SIGN REVIEW BOARD MEMORANDUM

FROM: The Office of the City Manager **DATE:** April 22, 2024
SUBJECT: SRB24-0009 Public hearing and consideration of a request from Hancock Sign Company for a variance to Chapter 106 (Signs) of the North Richland Hills Code of Ordinances at 5131 Rufe Snow Drive, being 1.02 acres described as Lot 6, Block 4, Tapp Addition.
PRESENTER: Clayton Comstock, Managing Director of Development Services

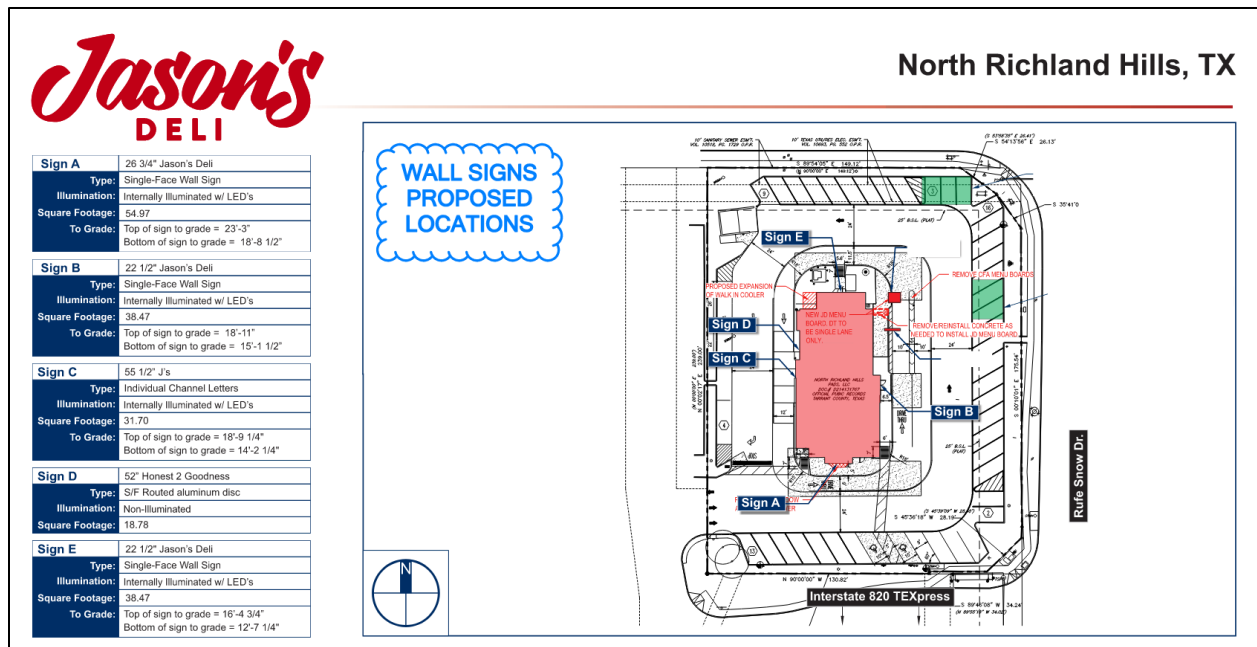
The site has street frontage on Rufe Snow Drive on the east and Combs Road on the north. It also fronts the signalized driveway entrance to the shopping center on the south. The west side of the building faces an internal driveway that connects to Combs Road.

Section 106-13(b)(1) of the sign regulations permits a structure to have wall signage on a maximum of two building faces, and those building faces must have a street frontage or public entrance. The applicant proposes to construct wall signs on all four faces of the building. A summary of the location and design of the wall signs are shown in the exhibit below. Detailed sign drawings are shown in the attached wall sign exhibits. The sizes of the wall signs are compliant with the sign regulations.
